UNITED STATES PATENT AND TRADEMARK OFFICE

10/713,788

Office Action Summary	Application No. 10/713,788	Applicant(s) REESE, KARL S.	
	Examiner Michael G. Mendoza	Art Unit 3731

DETAILED ACTION

FIG. 4

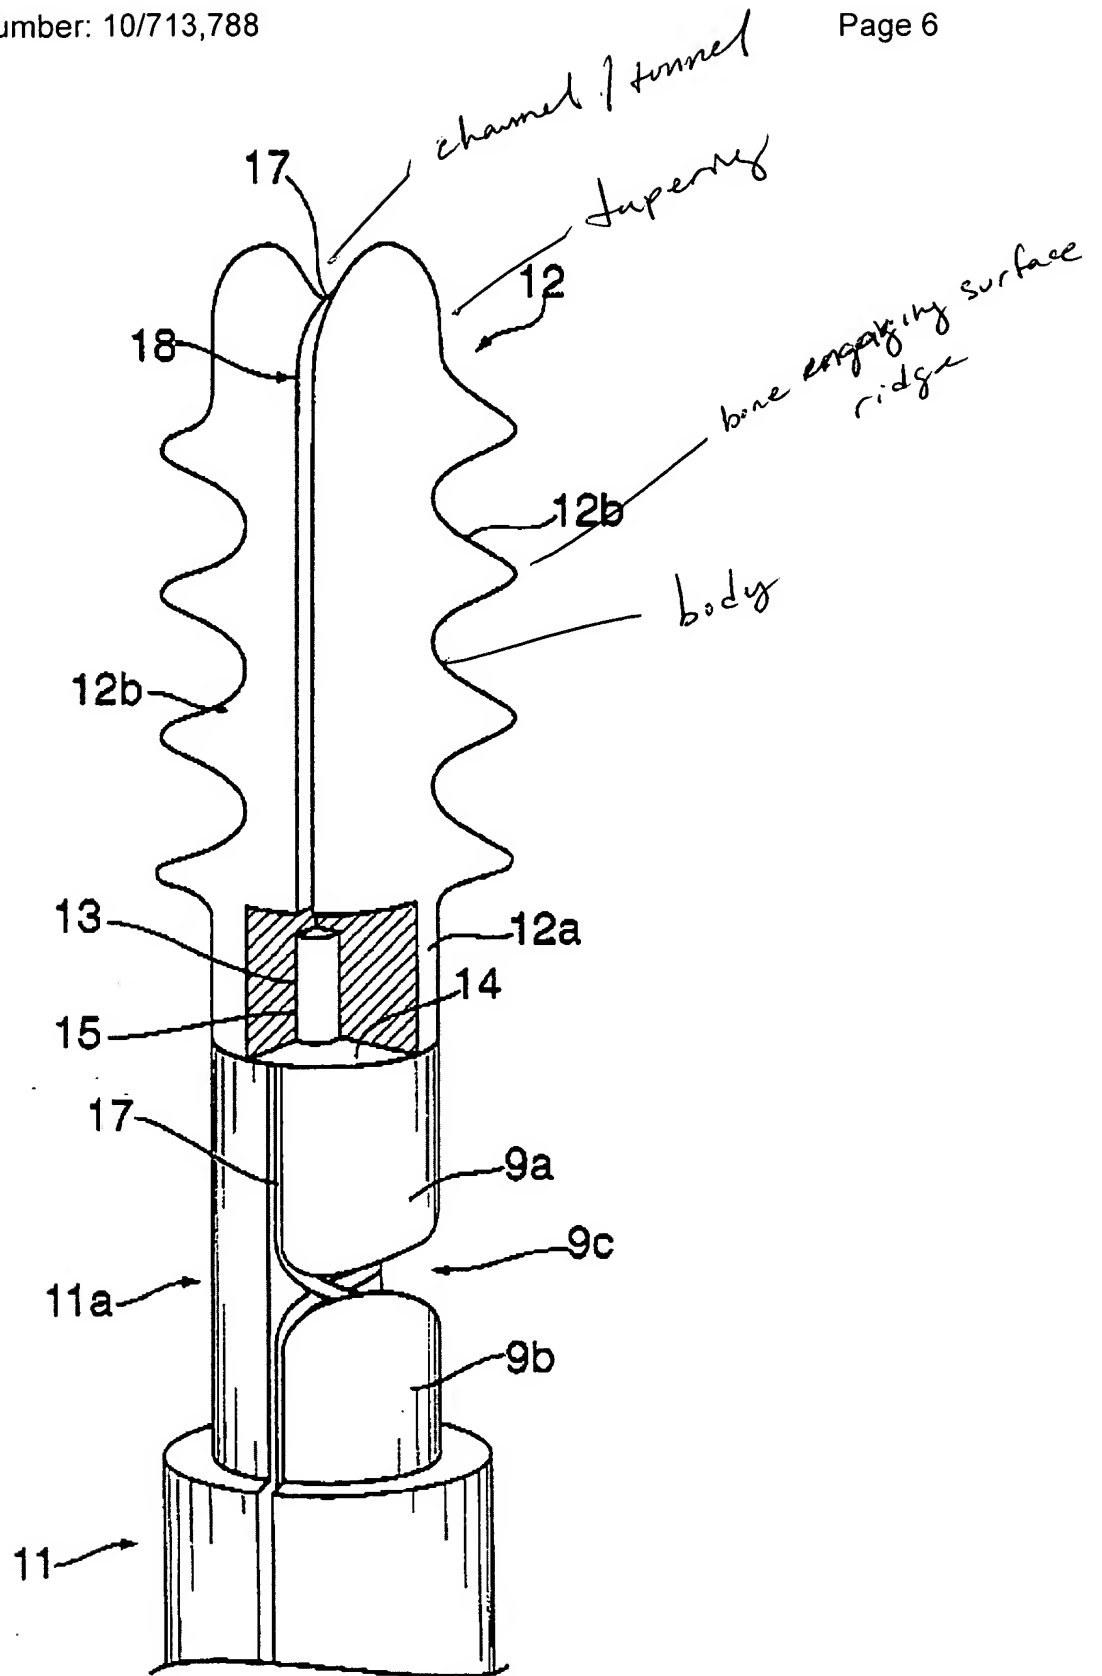
6. Tormala et al. teaches a suture anchor adapted to be disposed within bone, comprising: an elongate body having a proximal end, a distal end, and at least one discrete bone-engaging surface feature formed thereon and adapted to engage bone; a transversely-extending suture tunnel formed proximal to the distal end of the body such that the distal end of the body has a substantially solid distal tip; first and second

opposed suture-receiving channels formed in the body and extending from the proximal end of the body and terminating at the suture tunnel; and a suture loop disposed within the first and second opposed suture-receiving channels and the transversely-extending suture tunnel, the suture loop including a proximal portion positioned proximal of the proximal end of the body; wherein the first and second opposed suture-receiving channels are in communication with the suture tunnel; wherein the elongate body includes a plurality of discrete bone-engaging surface features formed thereon and adapted to engage bone; wherein the first and second opposed suture-receiving channels are adapted to seat the suture loop flush or sub-flush with an outer surface of the body; wherein the first and second opposed suture-receiving channels are fully capable of seating and engaging the suture loop, yet allow slidable movement of the suture loop; wherein the elongate body tapers from a proximal end to a distal end; and a driver-receiving element 4 formed in the proximal end of the elongate body.
